MIL-C-48882D (AR)
AMENDMENT 2
23 August 1994
SUPERSEDING
AMENDMENT 1
25 September 1992

MILITARY SPECIFICATION

CHARGE, PROPELLING, 81MM
PARTS AND CONTAINER ASSEMBLY

FIGURE 1.
Apparatus for the determination of nitrocellulose by the Schulze-Tiemann method

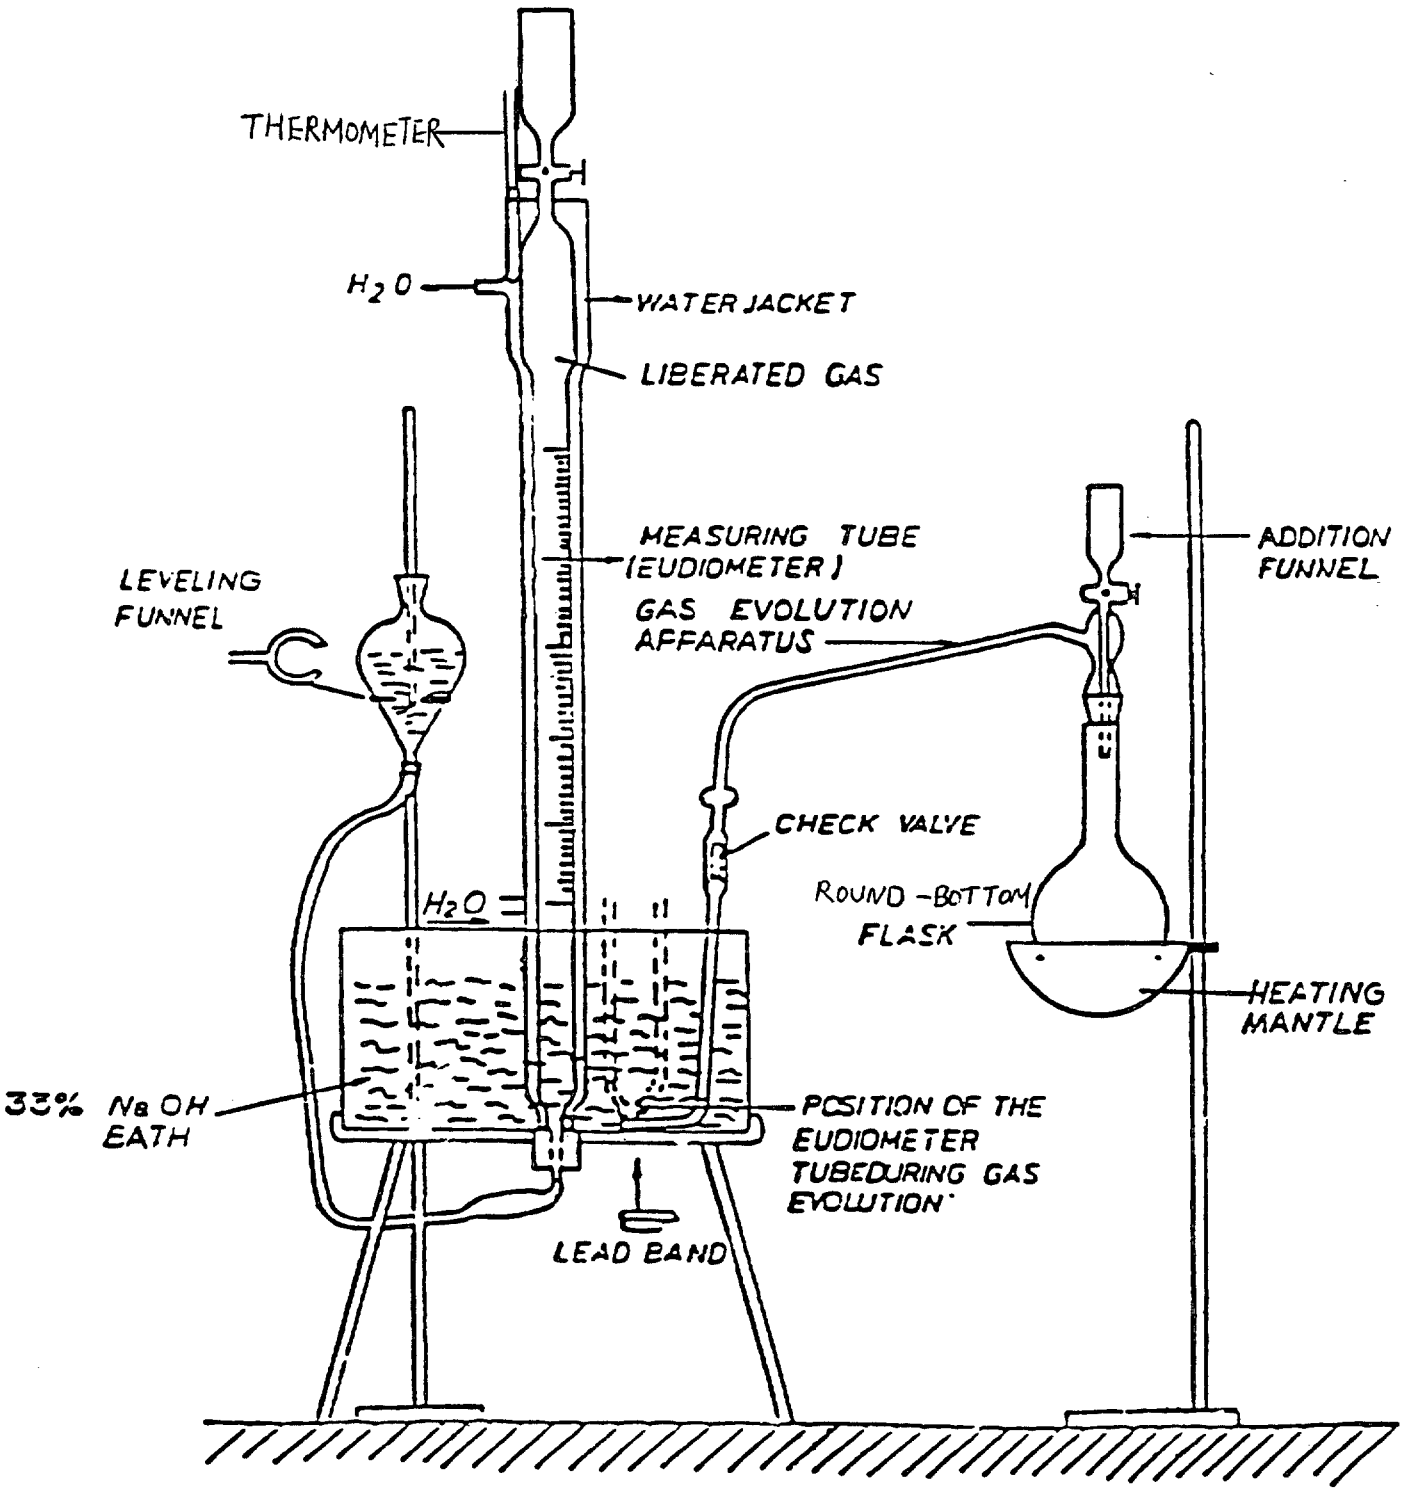
* Delete Figure 1 and substitute a new Figure 1 (attached).

Assemble a 250-ml round-bottom flask, gas evolution apparatus, eudiometer tub, NaOH bath, led band, heating mantle and leveling bulb as shown in Figure 1.
